# Modification Recommended Service Note

Supersedes:  
J7201C-01

## J7201C Attenuation Control Unit, DC to 26.5 GHz, 0 to 101 dB, 1-dB Steps

Serial Numbers: MY59400001 to MY61410049

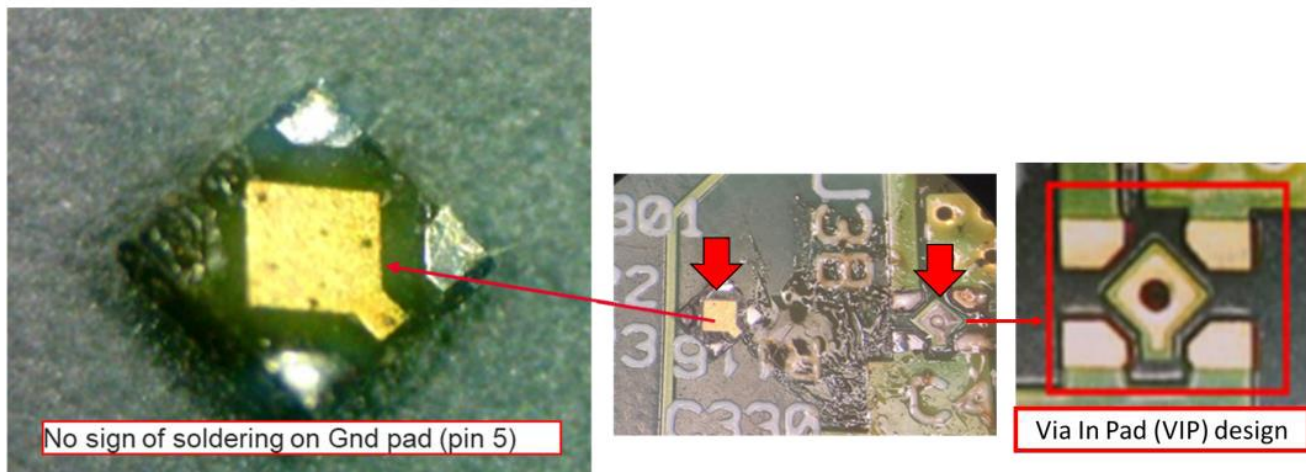
The instrument is unable to boot up and is stuck on the boot-up screen as follows. It is not functioning.

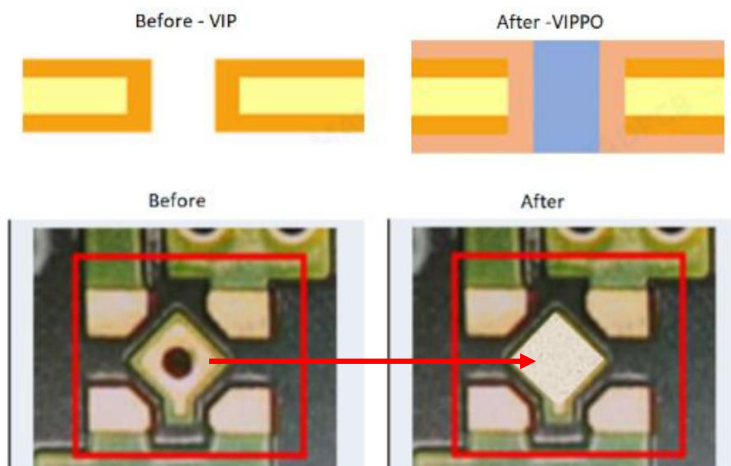
Failure analysis had indicated defective on P0600-63004 board where insufficient solder was observed at 2 locations. The insufficient solder was due to Via in Pad (VIP) where the melted solder had flown to the secondary side of the PCB.

The improvements were made from Via in Pad (VIP) to Via in Pad Plated Over (VIPPO) as per below.

The improved PPMC board have Serial number P06006300423**2413**000007 onwards.

Replace PPMC board P0600-63004 with Programmed PPMC board serial number P06006300423**2413**000007 onwards where 13 is the work week and 24 is the year.
